Appln. No. : John P. Biel, Jr. et al  
Amdt. Dated : November 16, 2004  
Reply to Office action of : October 5, 2004  
Page 15

**REMARKS/ARGUMENTS:**

**Amendments to the Drawings:**

**FIG. 8**

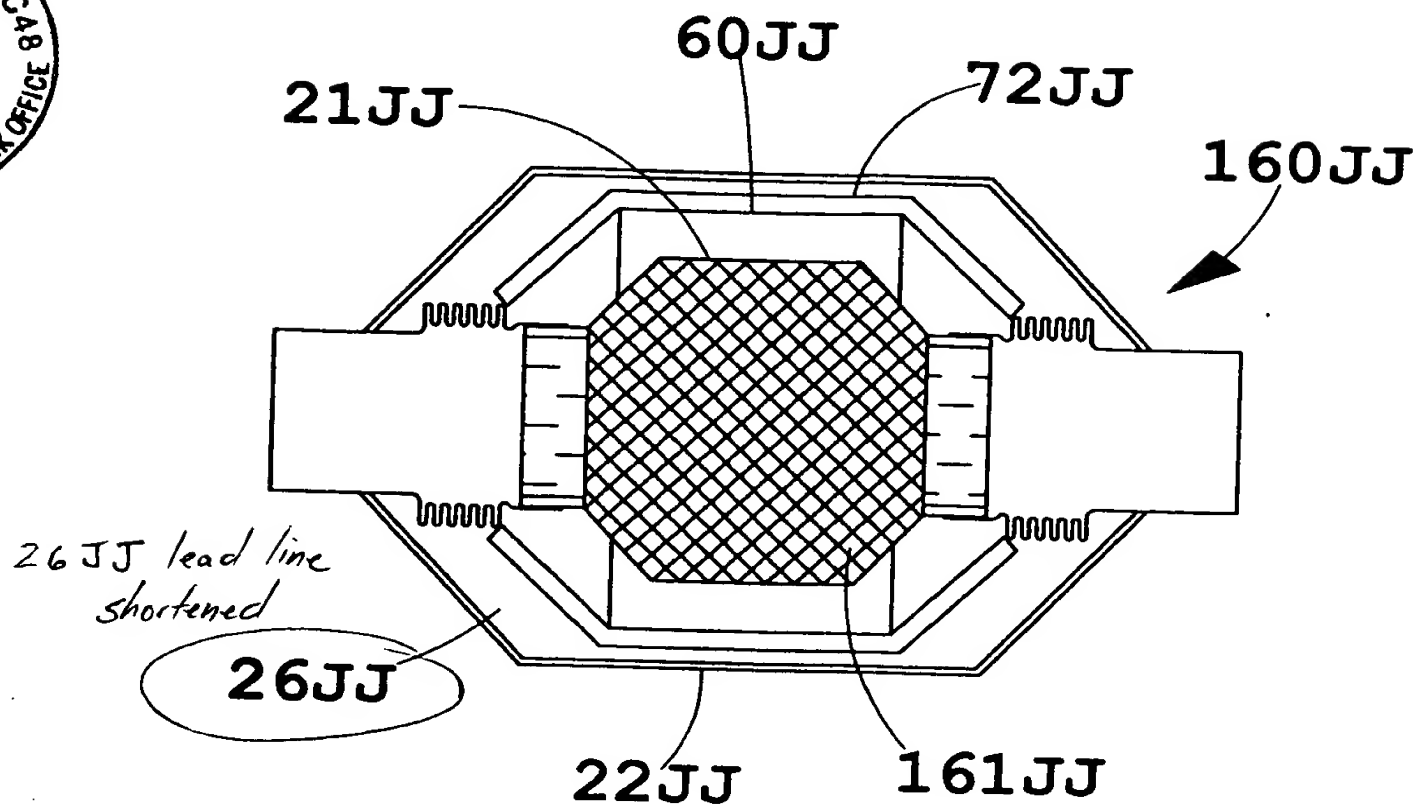
The attached sheets of drawings includes changes to Figs. 1, 2, 3 and 8. These sheets replace the original sheets for Figs. 1, 2, 3 and 8. In Fig. 1 and 2, previously omitted elements 49" and 90A have been added. In Fig. 3, elements 21B and 22B have been corrected to point to the inner housing and outer housing, respectively and Fig. 8 has been amended to show that the lead line for element 26JJ points to the vacuum cavity.

**FIG. 1**

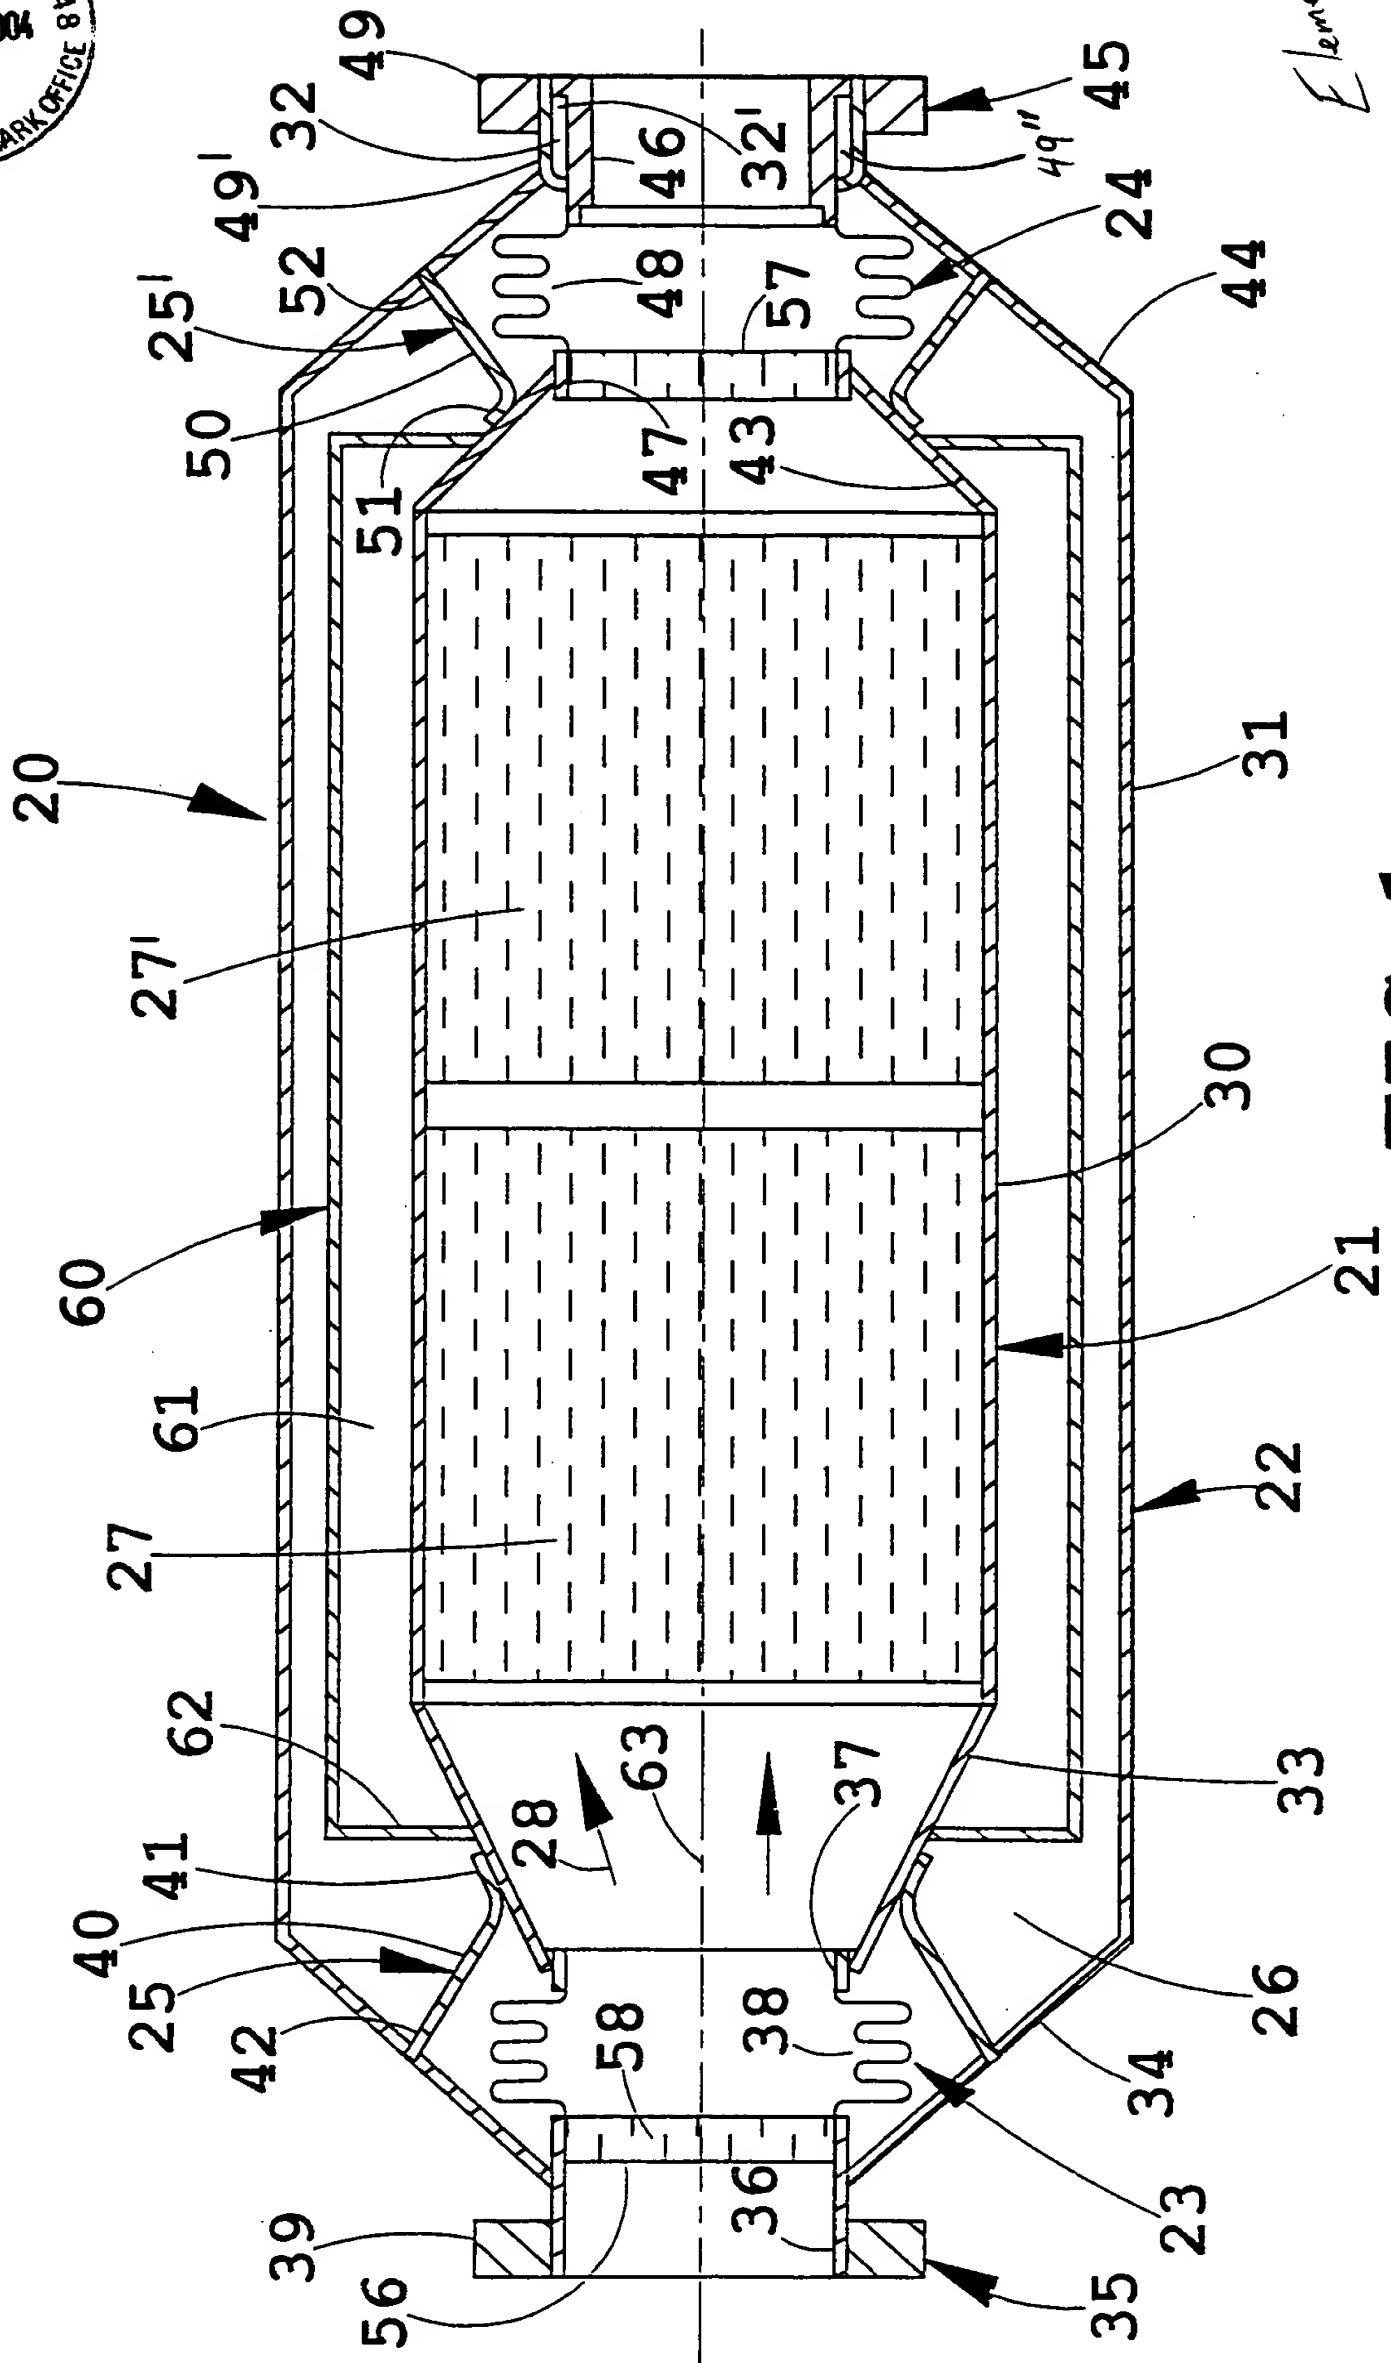
A request to amend Figs. 1, 2, 3 and 8 is submitted herewith. Examiner states that "the drawings are objected to as failing to comply with 37 CFR 1.84(p)(5) because they include the following reference characters not mentioned in the description: 49" (page 6, line 6); 90A (page 10 line 27)." In Fig. 1, the reference character 49", which points to an "annular space," has been added to conform with the requirements set forth in 37 CFR 1.84. Furthermore, in Fig. 2, the reference character 90A has been added to point to the "electrical circuit" and a lead line has been added pointing 99A to the "sensor" to which it pertains. Reference characters 21B and 22B in Fig. 3 have been changed to point to the inner housing and outer housing, respectively. Furthermore, in Fig. 8, the lead line for reference character 26JJ has been shortened to point to the "vacuum cavity." No change was made with respect to the reference character 91II, as this reference character is present in Figs. 6 and 7 and is defined in the specification at page 14, line 16.

*Element 49"  
 added*
